*Our Reference:* 0313442L01\_DPI RESPONSE.DOCX

**RE: RESPONSE TO DPI DRAFT COMMENT ON FURTHER  
SUBMISSIONS, SSD-5041, 45 AND 23-43 TATTERSALL ROAD,  
KINGS PARK, NSW**

**Figure 1 - Proposed Site Layout**

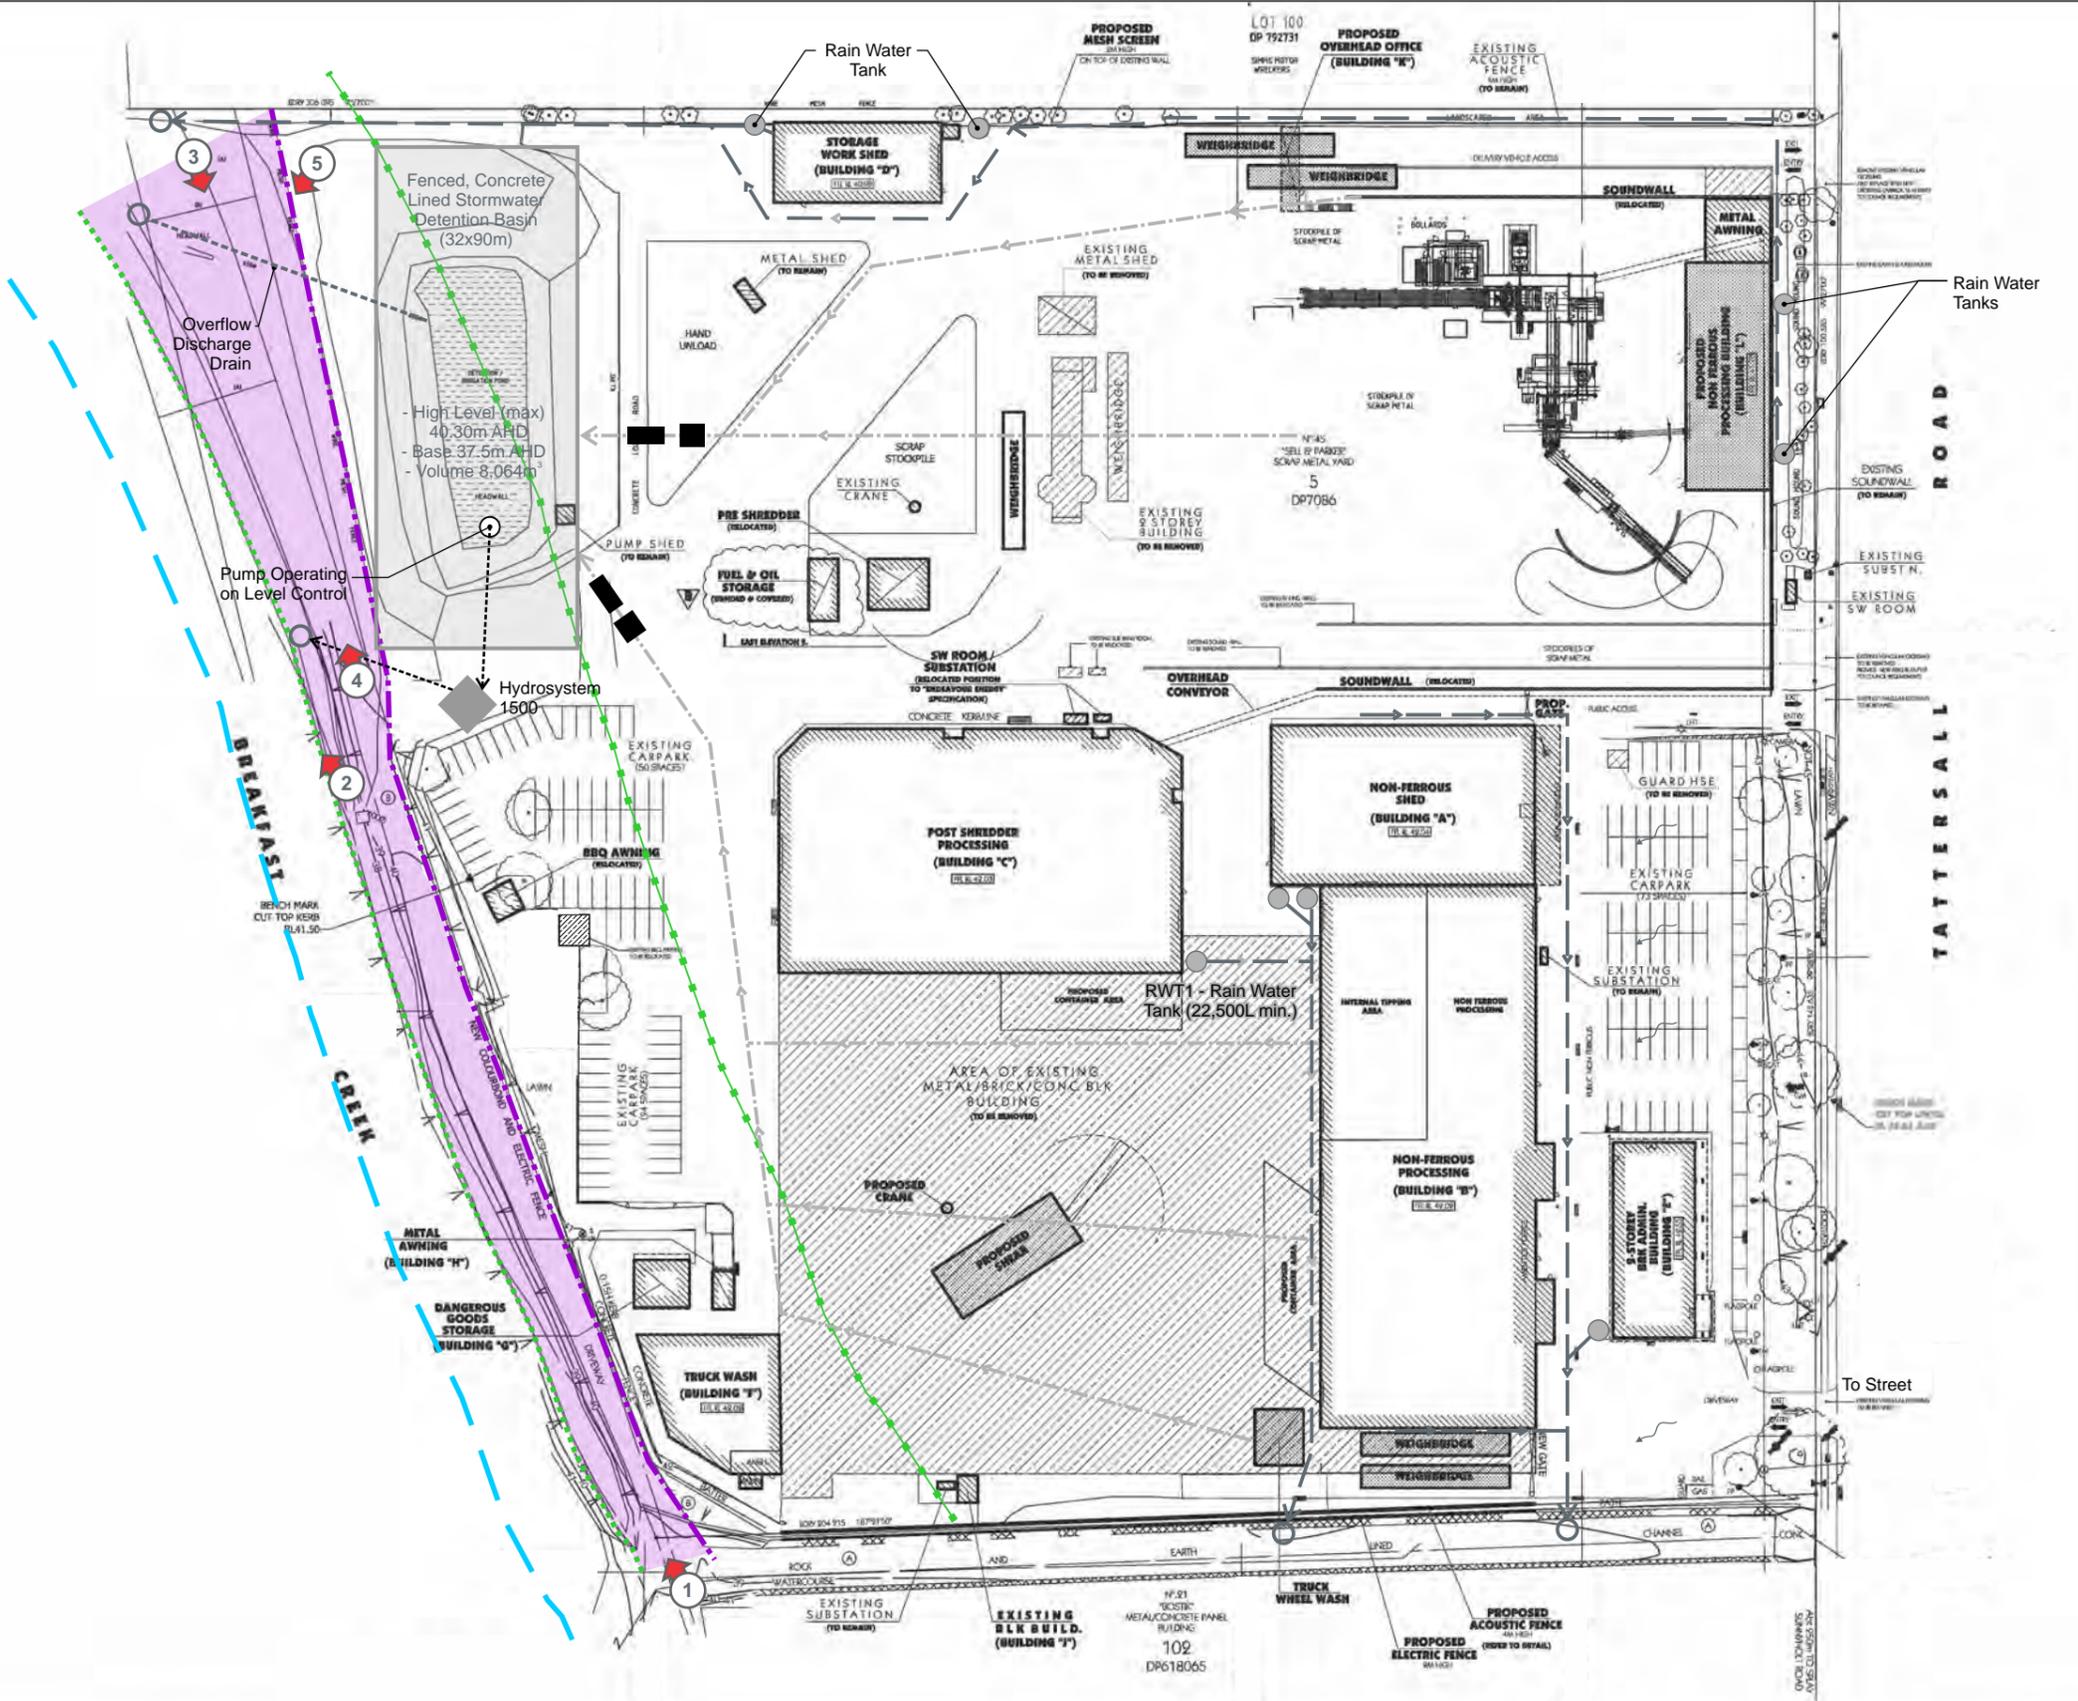
- a) The extent of the riparian zone should be specified. DPI Water notes that the 1996 Development Consent for the current Metal Recycling Facility specifies a 50m wide zone measured from the Breakfast Creek bank, which is to be "heavily vegetated"
- b) A permanent physical barrier (eg, bollards, logs, pathway or road) at the edge of the specified riparian zone to prevent damage to the vegetation
- c) Preparation of a Vegetation Management Plan

DPI Water's comment on groundwater requested clarification of the proposed stormwater retention basin base level relative to the water table, and requesting consultation should the base of the basin be below the water table.

Figure 1 attached shows the location of the top of Breakfast Creek banks and the location of the 50m line from the banks superimposed on the proposed site layout. It is clear that on the eastern part of the site (currently occupied by Dexion and not part of the existing Sell & Parker facility) that the 50m zone cuts across areas proposed for operations. There are currently existing buildings in this area. Within the current site area, it would be possible to maintain the 50m zone, provided that the stormwater retention basin is permissible within the zone.

Figure 1 also shows the zone which currently forms the buffer between the site and the Creek, in which Council has recently undertaken extensive works on Sell & Parker land which are shown in the attached photographs. This has resulted in removal of vegetation that was previously present, which ERM understands was done without consulting Sell & Parker. Council's actions are outside the control of Sell & Parker; consequently if Council has decided to undertake works in the riparian zone, it should be Council's responsibility to maintain them. The shaded zone is outside the proposed area for the development, and is separated from the operational site by a boundary fence and an earth bund.

ERM considers that it is not reasonably possible for Sell & Parker to undertake management of Council's landscaping in the riparian zone outside the operational boundaries. Within the operational boundaries, the proposed layout provides for maintenance of the majority of the existing vegetation (which is present in a strip along the site boundary, with a wider area including trees around the stormwater retention basin). Replanting to improve the landscaping along the boundaries should be included as part of the proposed development.

The proposed stormwater retention basin is 2.8m deep. The ground level in the proposed development is approximately equal to the current ground level in this area of the site. Based on the available information, it is expected that this depth is approximately 0.5-1m above the water table. During detailed design phase, a site investigation is planned, which will include obtaining groundwater levels in the area of the basin. The intention is that the basin will have a base above the water table by at least 0.5m. If intercepting the water table is unavoidable, DPI Water should be consulted.
